**Consolidated Statements from Opponents of
the 2nd Story Project at 985 Channing Avenue, Palo Alto**

The plans were received on 08/24/20 for review by Planning Staff. Based on the initial feedback from staff, the application **cannot be deemed complete at this time**. A revised set of plans incorporating the following information and requirements must be submitted for review:

DUNLAP RESIDENCE

985 CHANNING AVENUE
PALO ALTO, CA 94301

EXISTING & PROPOSED SITE PLANS

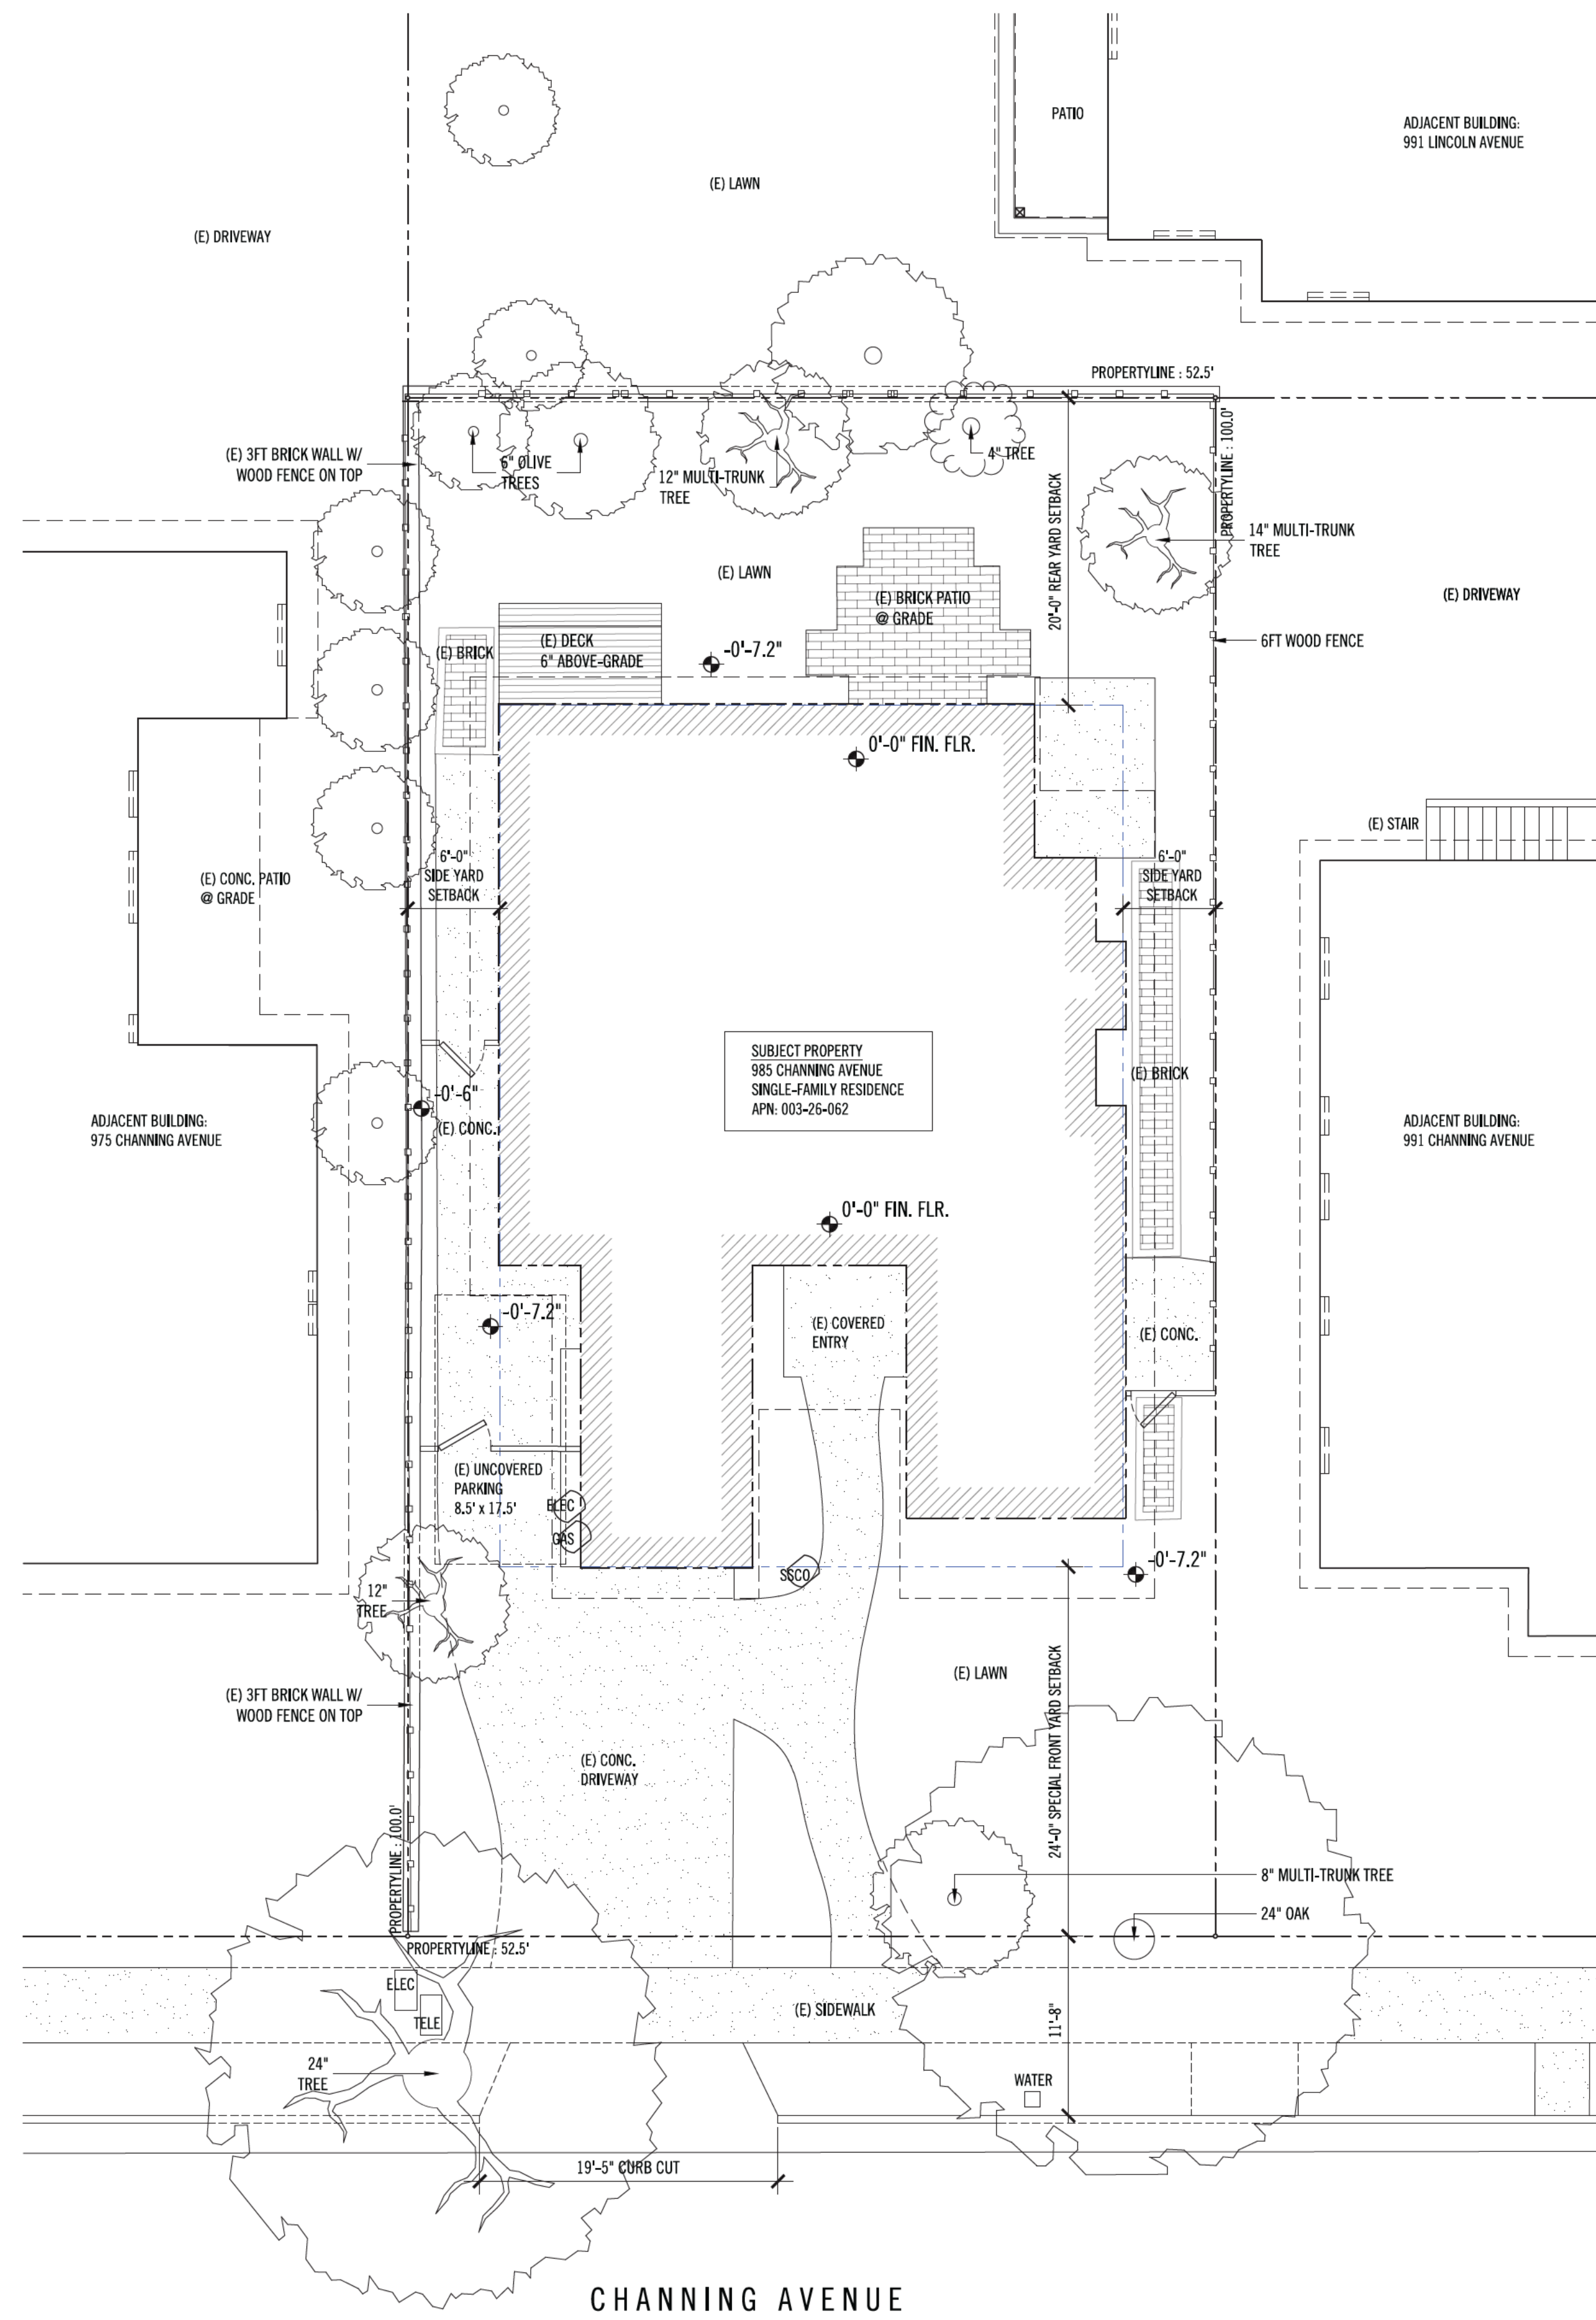
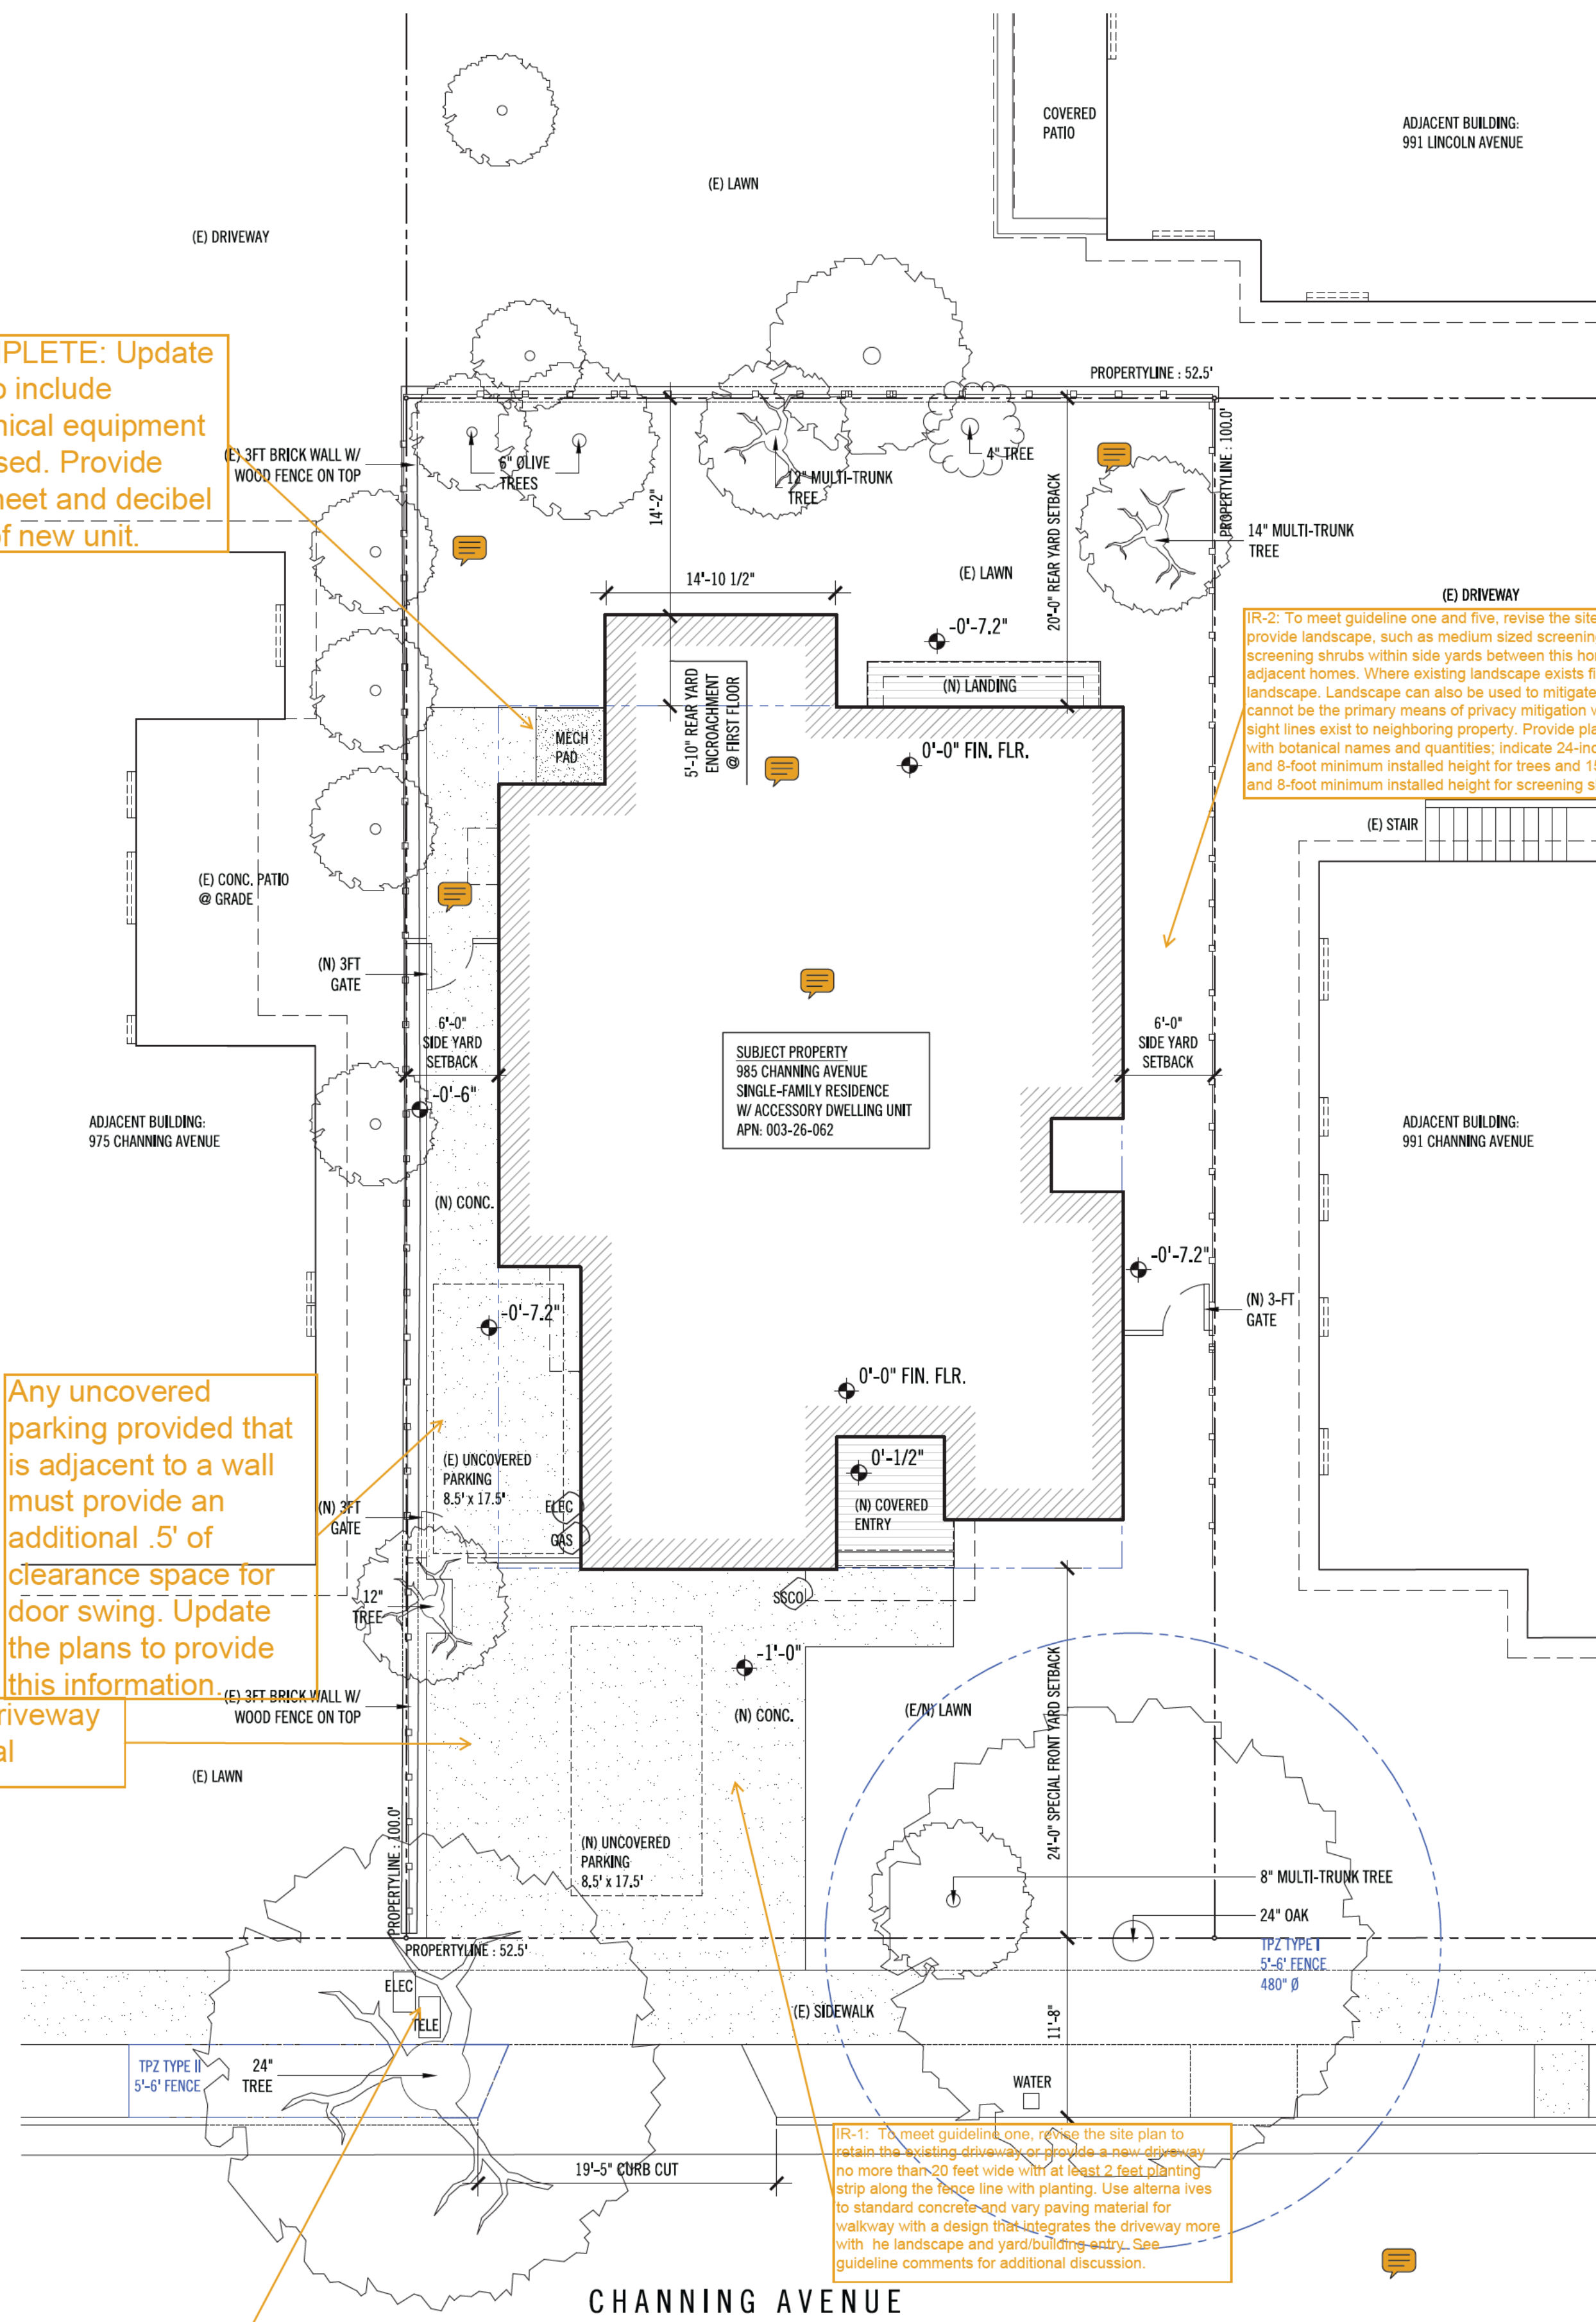
INCOMPLETE: Update plans to include mechanical equipment to be used. Provide spec sheet and decibel rating of new unit.

Any uncovered parking provided that is adjacent to a wall must provide an additional .5' of clearance space for door swing. Update the plans to provide this information.

Note driveway material

Update to show

IR-2: To meet guideline one and five, revise the site plan to provide landscape, such as medium sized screening trees or tall screening shrubs within side yards between this home and adjacent homes. Where existing landscape exists fill gaps in the landscape. Landscape can also be used to mitigate privacy, but it cannot be the primary means of privacy mitigation where direct sight lines exist to neighboring property. Provide plant choices with botanical names and quantities; indicate 24-inch box size and 8-foot minimum installed height for trees and 15-gallon size and 8-foot minimum installed height for screening shrubs.
